Q03782

PROPOSAL DRAWING

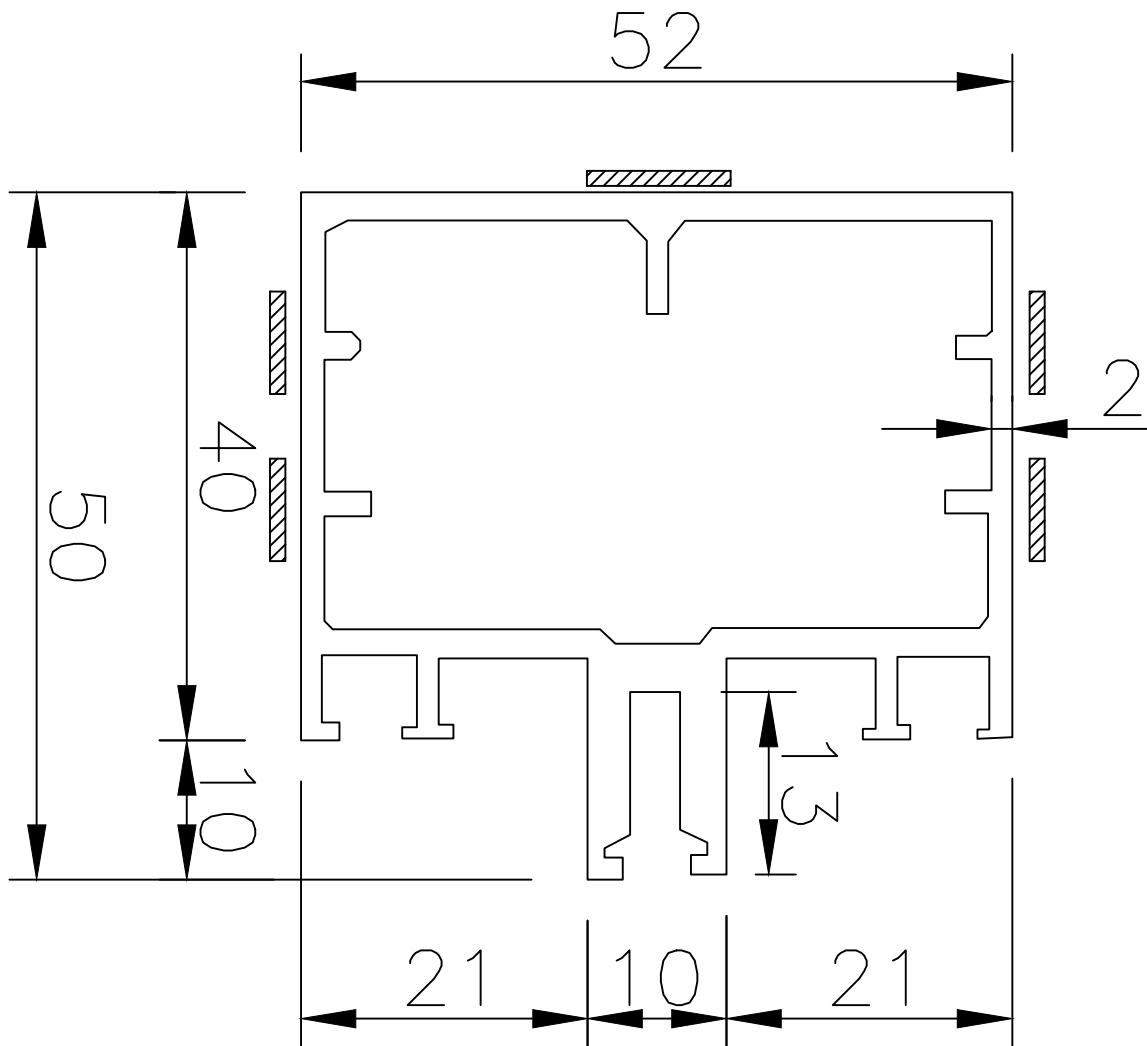
DUE TO THICKNESS VARIATION WE MAY GET IMPRESSIONS MARKED THESE PLACES
